SUBJECT: SUMMARY OF SITE VISIT AND MEETING ON GROUNDWATER LEVEL MONITORING  
AND CONTROL (TACS 56472 AND 56473)

SUBJECT: SITE VISIT TO MCGUIRE NUCLEAR STATION AND MEETING  
WITH DUKE POWER COMPANY REGARDING THE TECHNICAL  
SPECIFICATION FOR THE PERMANENT DEWATERING SYSTEM

Re: McGuire Nuclear Station  
Unit 2 Reactor Building  
Exterior Groundwater Monitor  
Follow-up to Handwritten letter  
of January 19, 1988  
File No.: MC-1124.07

ATTACHMENT 2

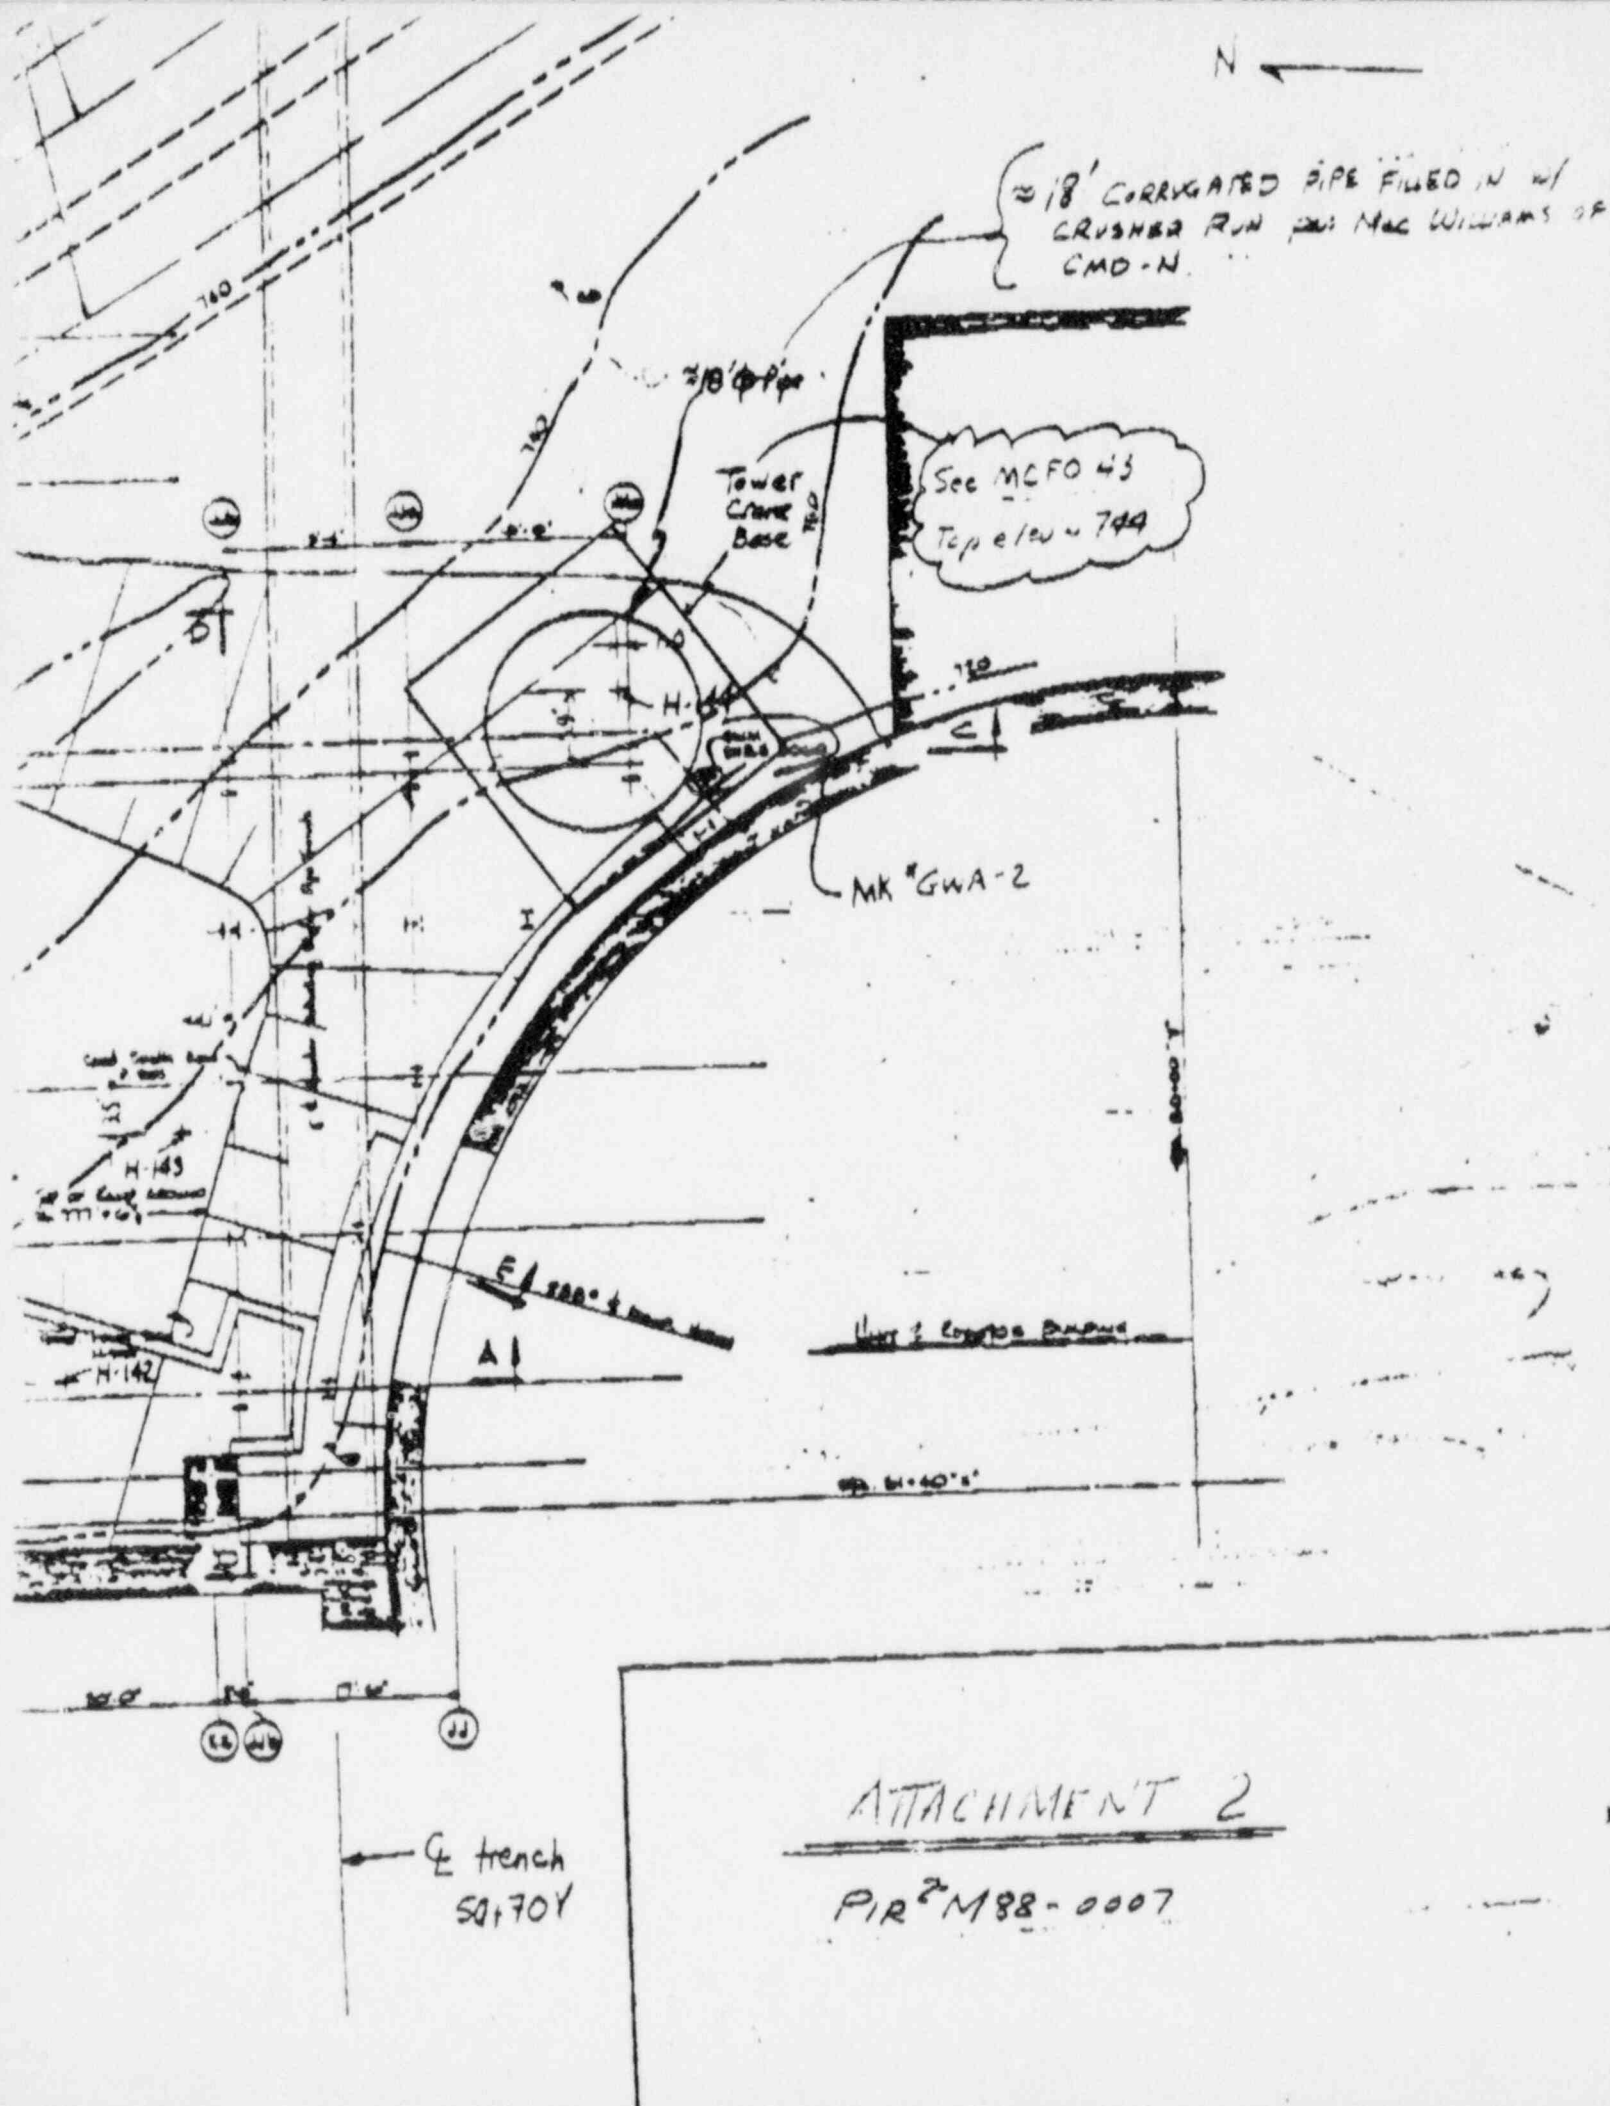
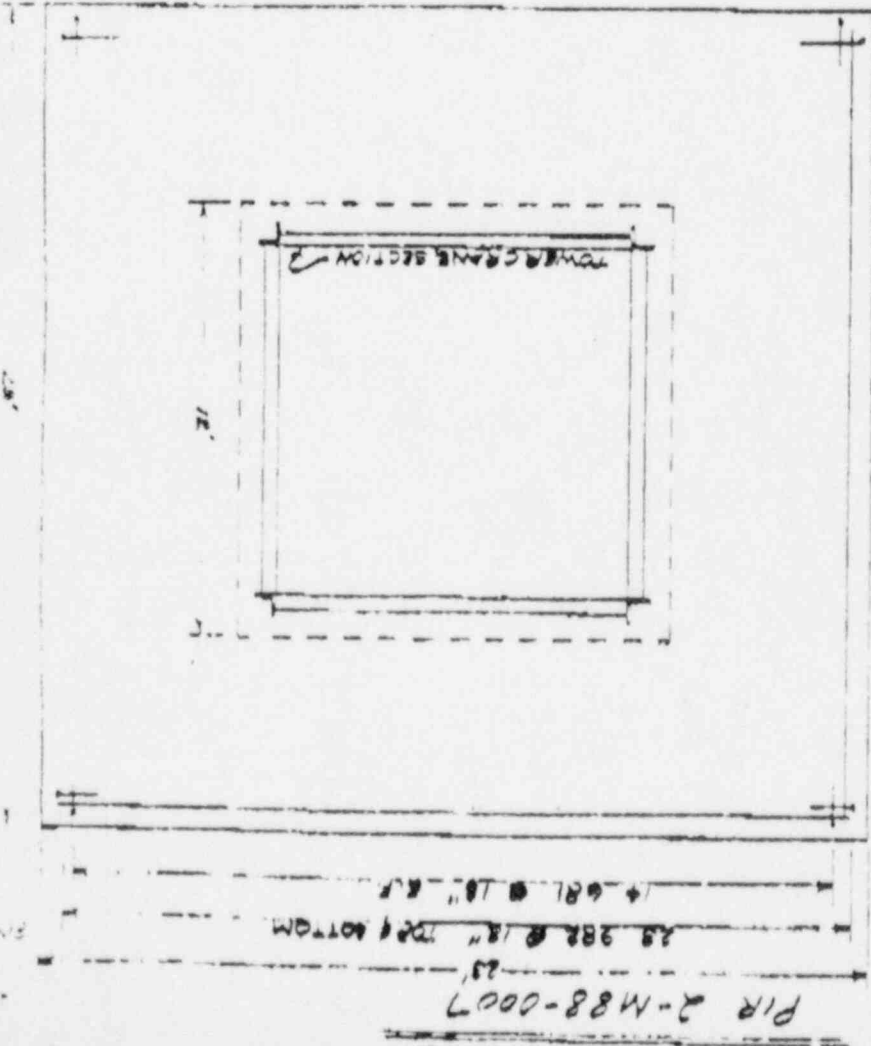
The original Unit 2 Reactor Building Tower Crane Base is located in close proximity to the subject groundwater monitor (see Attachment 2). This base consists of a 23' x 23' x 10' deep reinforced concrete slab with the top of the slab being at approximately Elevation 744+0. The bottom section of the crane was embedded in the slab as shown on construction drawing No. MCFD-43 (see attachment 3 and 4). A corrugated metal pipe, approximately 18 feet in diameter, was placed around the bottom portion of the crane tower and extended from the base to several feet above the base (see Attachment 5). This pipe served as a barrier for the tower crane against soil and groundwater while fill material was being placed and compacted in the area around the crane base.

This man-made "basin" would help explain the alarming of Groundwater Monitor MK.GWA-2. The crane base and associated corrugated pipe probably collect rainwater. This water could eventually migrate to the nearby groundwater monitor and enter the groundwater well, with the result being an activation of the alarm for this monitor. This type of scenario would obviously not reflect a true indication of the groundwater levels in the area.

In addition, the Tower Crane Base may be a source of disruption for the Zoned Wall Filter, which extends around the Reactor Building between the east side of the Unit 2 Auxiliary Building wall and the Unit 2 Outside Doghouse. The Zoned Wall Filter drains the surrounding groundwater levels down to the Underdrain System, which eventually collects the water into three sumps contained in the Auxiliary Building. Any disruption of the Zoned Wall Filter could affect the flow of the groundwater to the Underdrain System, possibly causing a buildup of water around the disrupted Zoned Wall Filter (or crane base). In our specific case, it is evident that the crane base at least partially penetrates the Zoned Wall Filter.

Although the Civil Engineering Section does not believe that the alarmed groundwater monitor presents a significant problem, the following steps could be taken to further investigate the groundwater in this area.

- 1) Water samples could be taken from the subject well. These samples could be analyzed by the Chemistry Group at the site to determine the contents of the water.
- 2) Additional wells could be drilled in the vicinity of Groundwater Monitor MK.GWA-2 to better determine what the true groundwater levels are in this area.

BASE PAPER COMPANY  
 CONSTRUCTION DEPARTMENT  
 MCGUIRE NUCLEAR STATIC  
 TITLE  
 TOWER CRANE BASE  
 FOR PITCHER 1425  
 SCALE 1/4" = 1'  
 DESIGNER K. ROWE  
 DRAWING NO. MCFD-43

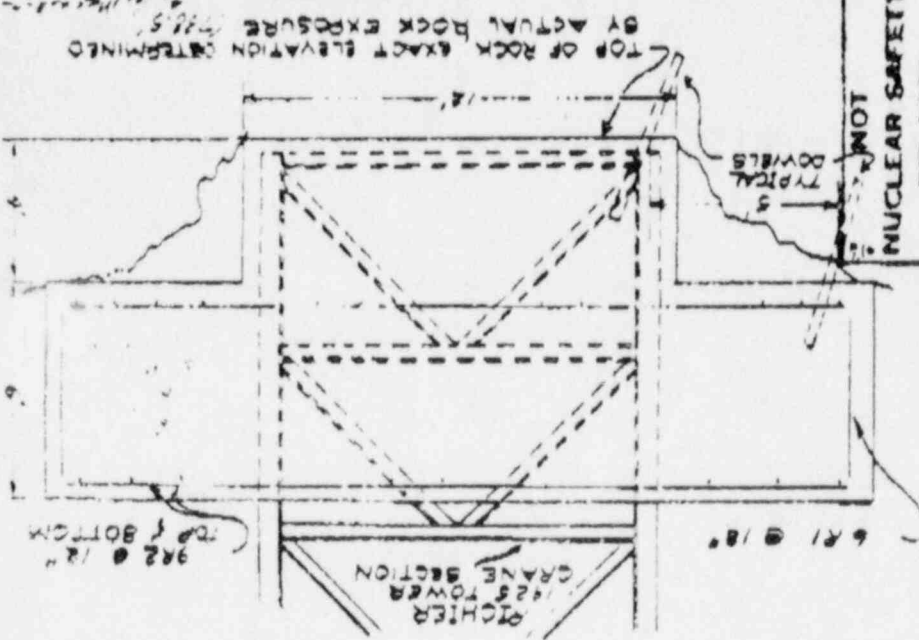
- A. RB is designed for a 750' water level.
- B. Other blags. protected by other wells, which are not alarming.
- C. GWA2 has spuriously alarmed in the past.
- D. The Tech spec water levels are unnecessarily restrictive.
- E. GWA2 is currently alarming @ level 725.0.
- F. GWA2 may be influenced by the old RB tower crane foundation, which is within 10' of the well.

### REVISION #4

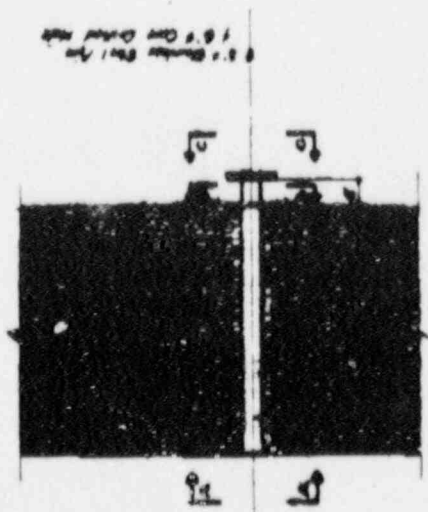
- ① This same groundwater monitor has alarmed several times in the past year. On those occasions, an adjacent Auxiliary Building groundwater monitor (located at Col. lines PP-61) with an initial alarm level of EL. 718+8, has not alarmed. This occurrence leads us to believe that the subject groundwater monitor and associated well is malfunctioning.

- ② If this groundwater monitor actually reflected the true groundwater conditions, and if we also assumed a worst case scenario of blockage of the underdrain system, the Reactor Bldg. walls are specifically designed for a maximum groundwater level of 750+0. The remaining monitors will still fall under the Tech. Spec. procedures. Since there is a Aux. Bldg. monitor located nearby with an initial alarm level at EL. 718+8, any indication of groundwater in this area will be noted. Also there is a monitor located inside of the Unit 2 Equipment Staging Bldg. (East side of Unit 2 Aux. Bldg.), which has an initial alarm level of 731+0, and two monitors located inside the Unit 2 Diesel Gen. Bldg. with initial alarm levels of 739+2.

Therefore, there are enough monitors nearby to indicate an <sup>unusual</sup> increase in groundwater. Other monitors do not show a general increase in the yard water table.

Conclusion: GWA2 alarming @ level 725.0 does not affect Unit 2 operability.
